## BULLETIN NO. 2

### 491/20167.SDW - PHASE 500: CENTER FOR FORENSIC PSYCHIATRY- CREATE KITCHEN SALINE, MICHIGAN

WTA Project No. 2021094  
MAY 14, 2025

SHEET NUMBER  
E6.01

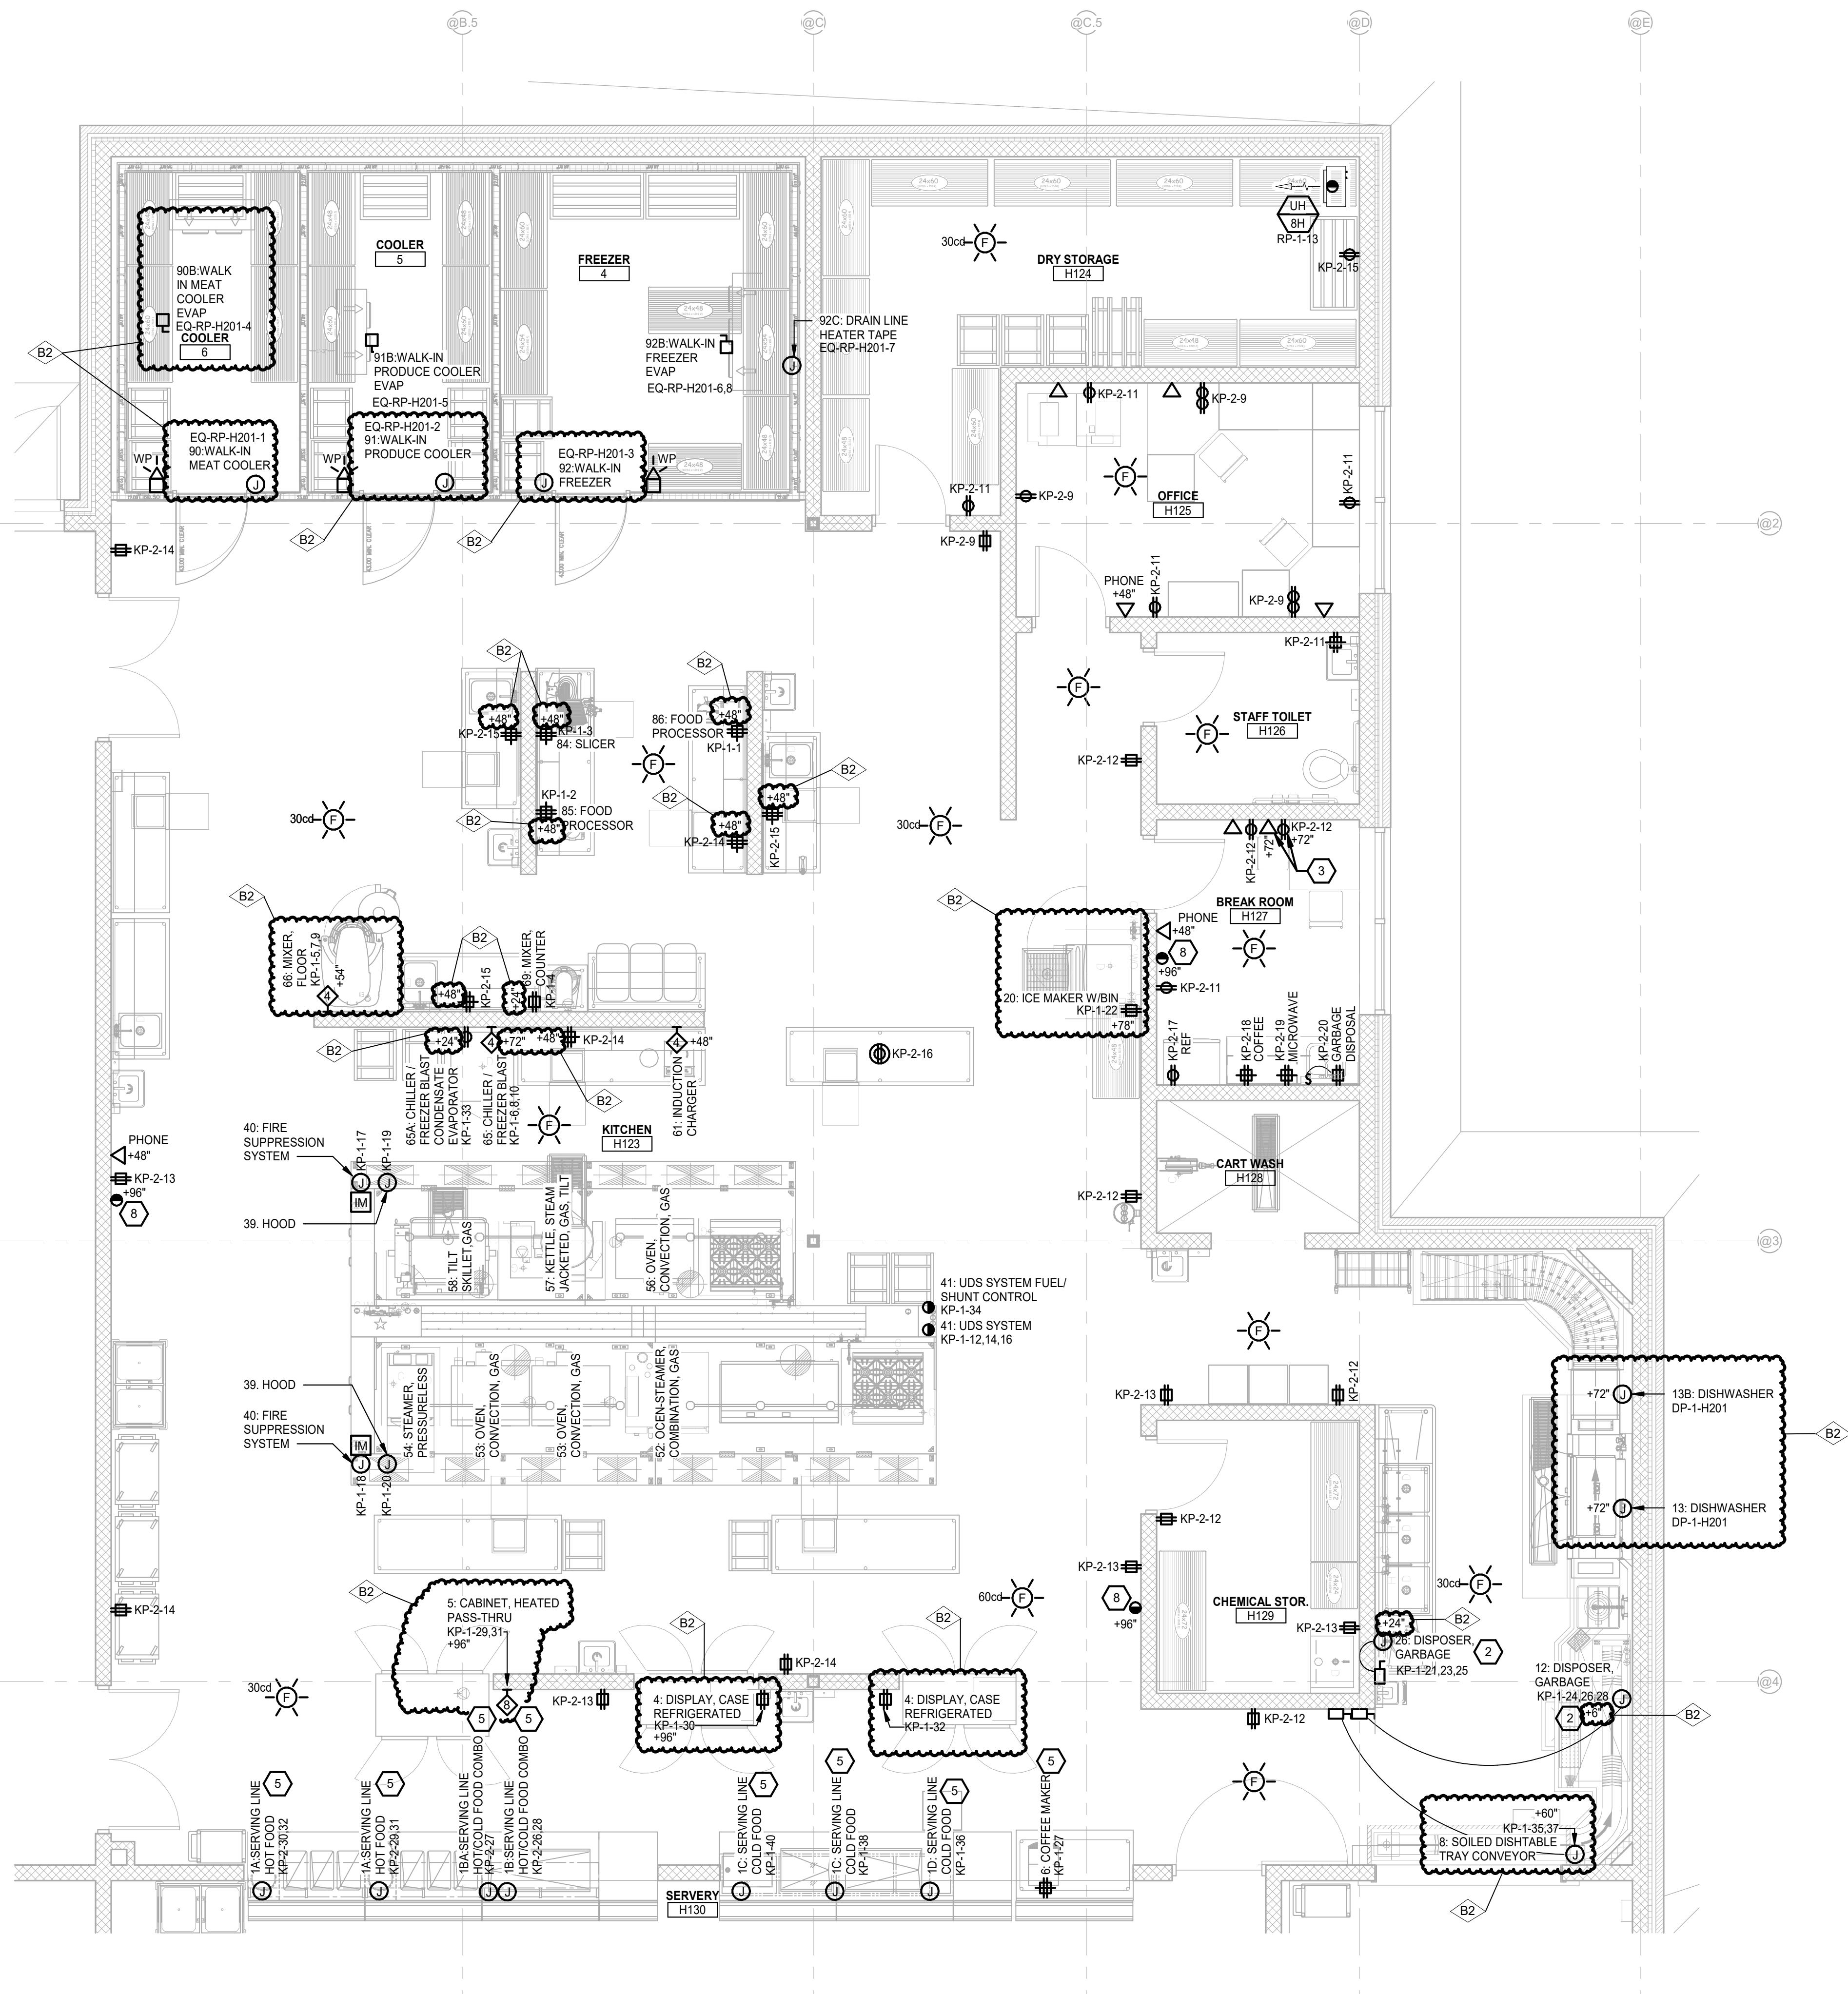
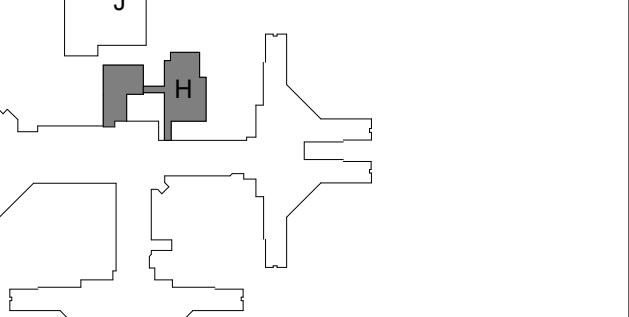
Item E5      Reference Sheet E6.01 (**Re-Issued**)  
A. Revise multiple receptacle heights and locations to coordinate with the food service drawings.  
B. Revise locations receptacles for items 4 and 5 from ceiling to wall.  
C. Revise circuit information for "8: soiled dishtray conveyor"  
D. Remove one of the connections called out for the dishwasher to coordinate with the food service drawings.  
E. Remove disconnect and change to receptacle for "66: mixer".  
F. Revise locations for walk-in cooler and freezer power connection.
